MONTGOMERY COUNTY DEPARTMENT OF PARKS
THE MARYLAND-NATIONAL CAPITAL PARK AND PLANNING COMMISSION

MEMORANDUM

MCPB 07/31/08
Item #18

SUBJECT: **SilverPlace**
139,700 Gross Square Feet of Office Space
Approximately 300 Housing Units
CBD-1 Zone
8787 Georgia Avenue, Silver Spring
Sector Plan for the Silver Spring CBD

Bozzuto Response to Staff Design Alternative

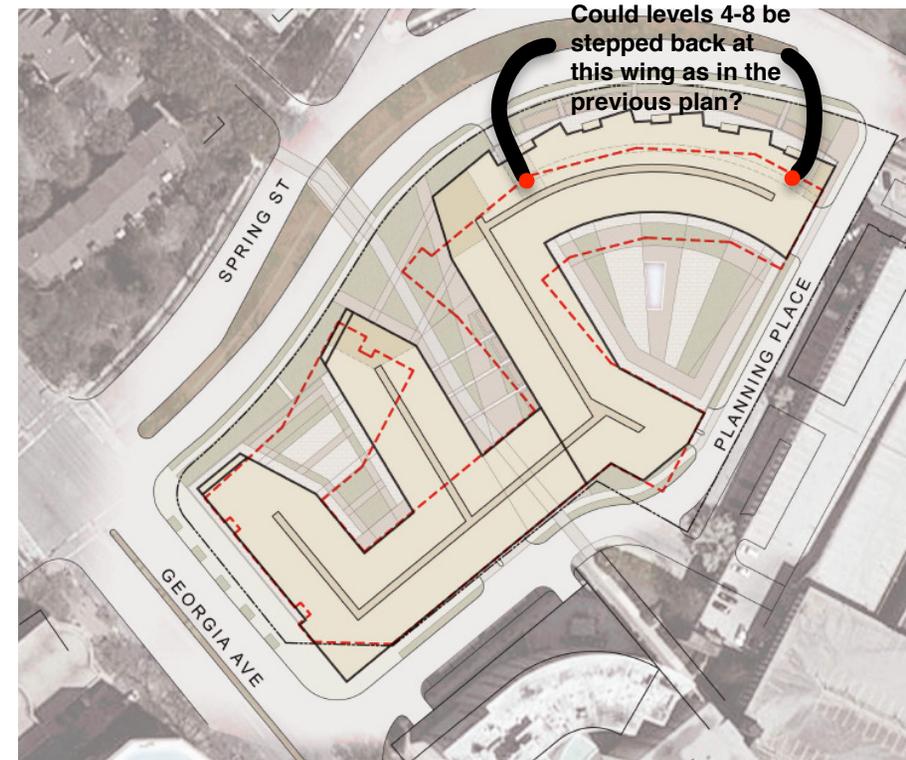
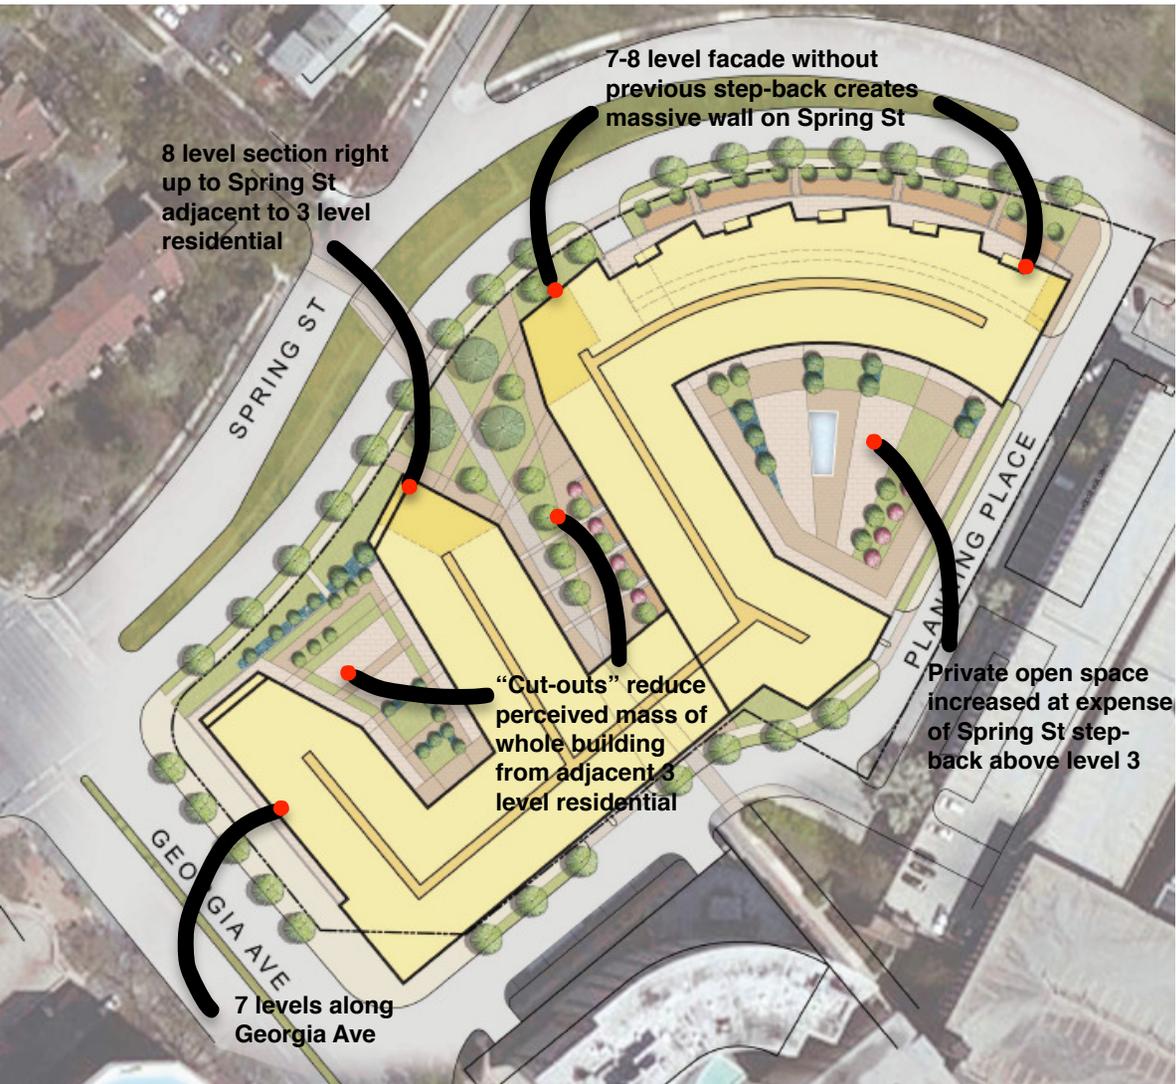
Bozzuto proposed alternative
(original submittal outlined in red)

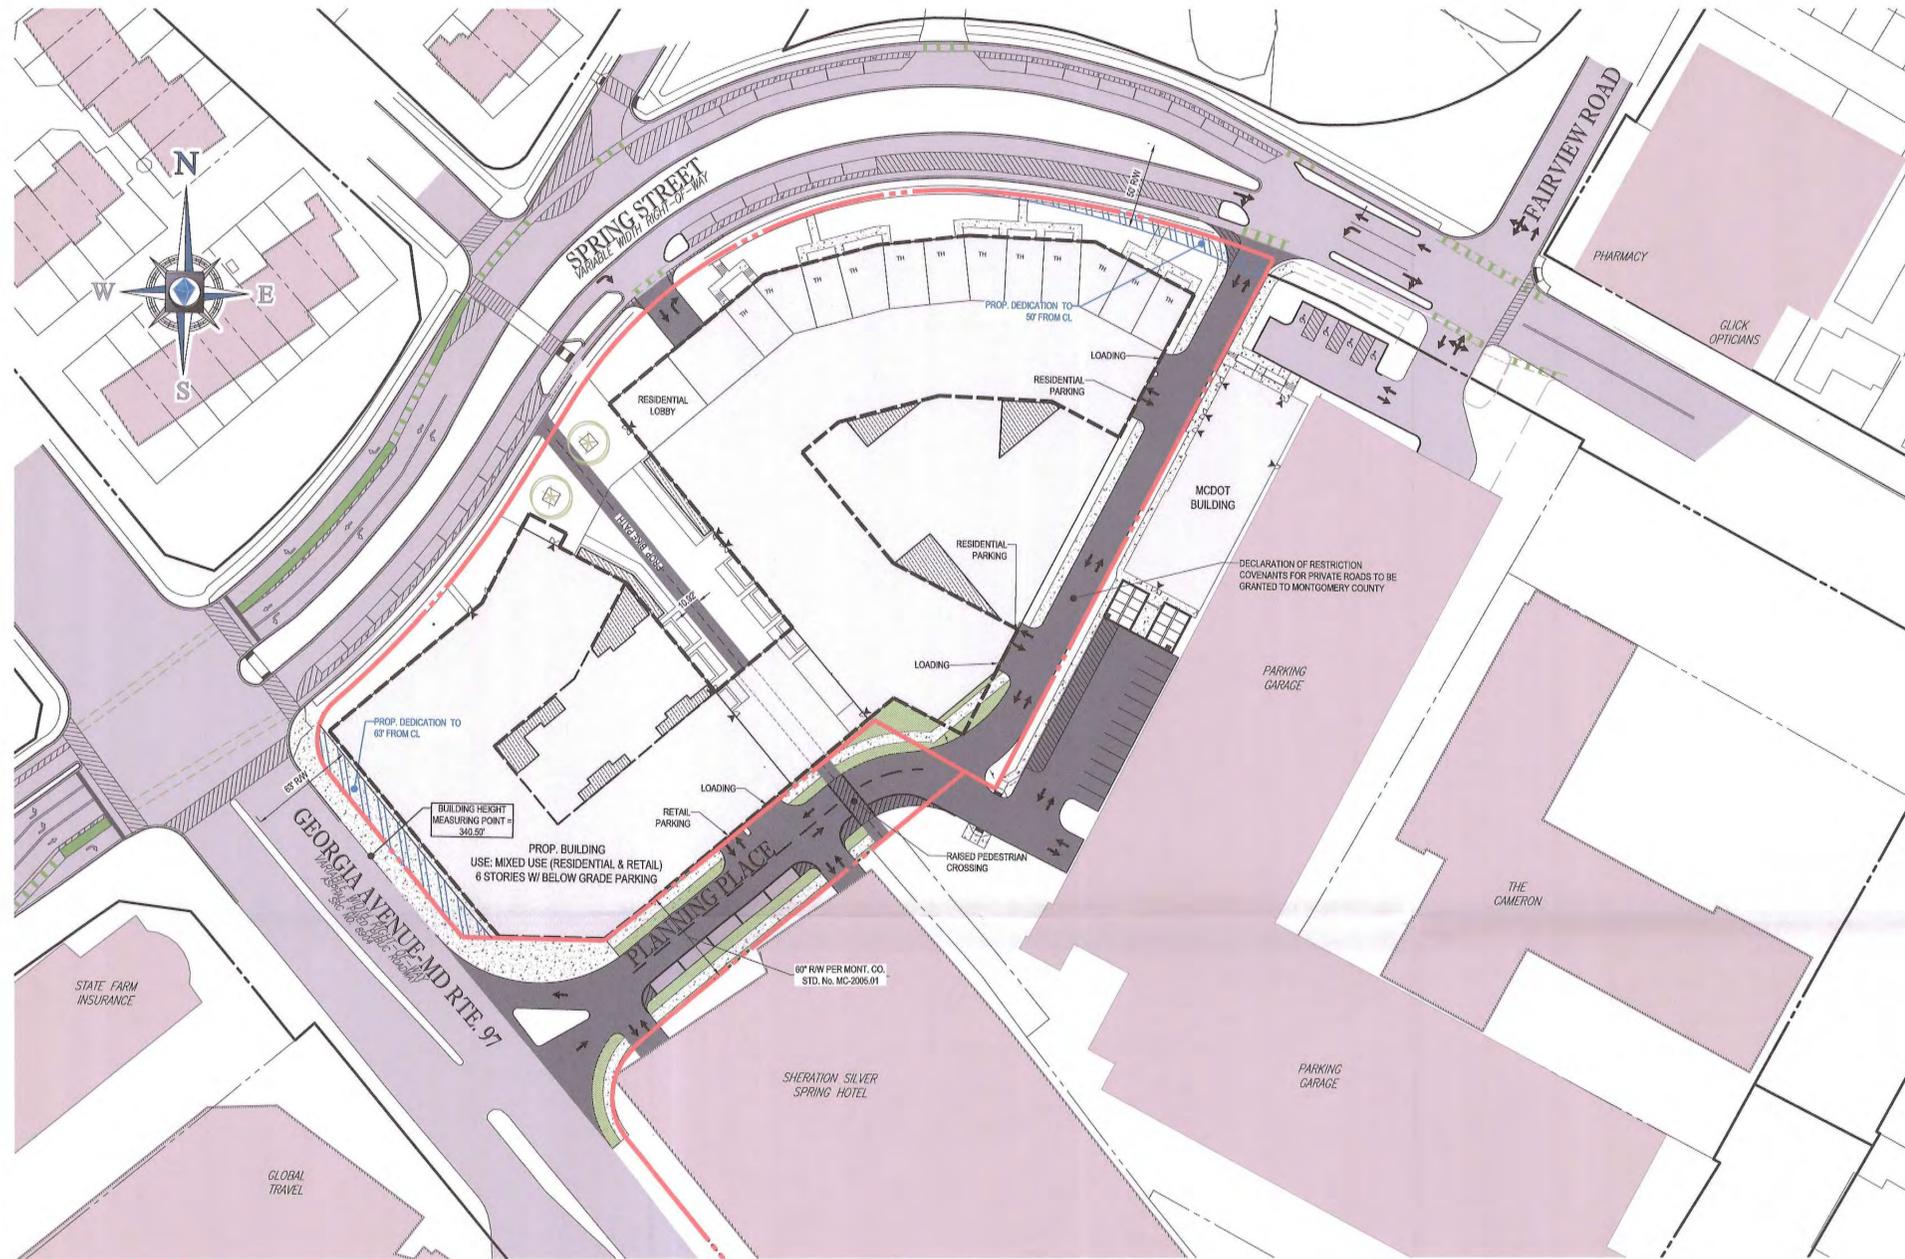
Sheet 2 (Sight Distance Exhibit) of the Site Access and Circulation Study appears to show minimum visibilities of two hundred fifty (250) feet along Spring Street and one hundred fifty (150) feet along Planning Place. A Design Exception, approved by this Department, will be necessary to allow a lower visibility requirement along the public portions of either of these roads. We are amenable to accepting lower sight distances requirement(s) if it can be confirmed that visibility needed for the existing 85th percentile speed(s) - during daylight, off-peak hours - is less than that needed for the roadway classification(s). We have not yet agreed to a lesser visibility requirement on either street.

It is not clear to us whether the sight distances shown on Sheet 2 are estimates of anticipated visibilities or the results of actual field measurements. Why did the study not include the County-standard Sight Distance Evaluation Certification Form – signed and sealed by a registered Professional Engineer or Professional Land Surveyor? What is the sight distance looking left from the proposed intersection of Planning Place and Spring Street?

Planning Place and Spring Street: The proposed intersection location does not meet the three hundred (300) foot intersection spacing criteria on an Urban Arterial Road now established in Chapter 50 of the County Code. Based on Sheet 1 of this study, it appears the centerline-to-centerline spacing on Spring Street – between its existing intersection with Fairview Road and the proposed intersection with Planning Place – is approximately one hundred and twenty five (125) feet. A Planning Board finding will be needed to allow a lesser separation between these intersections.

Existing driveways for the Sheraton Hotel: we note Sheet 2 indicates visibility for vehicles exiting the eastern driveway will be limited by the five parking and two bus spaces proposed on the south side of existing Planning Place. To provide better visibility for exiting vehicles looking left, extend the curb on both sides of the driveway instead of paint stripes.
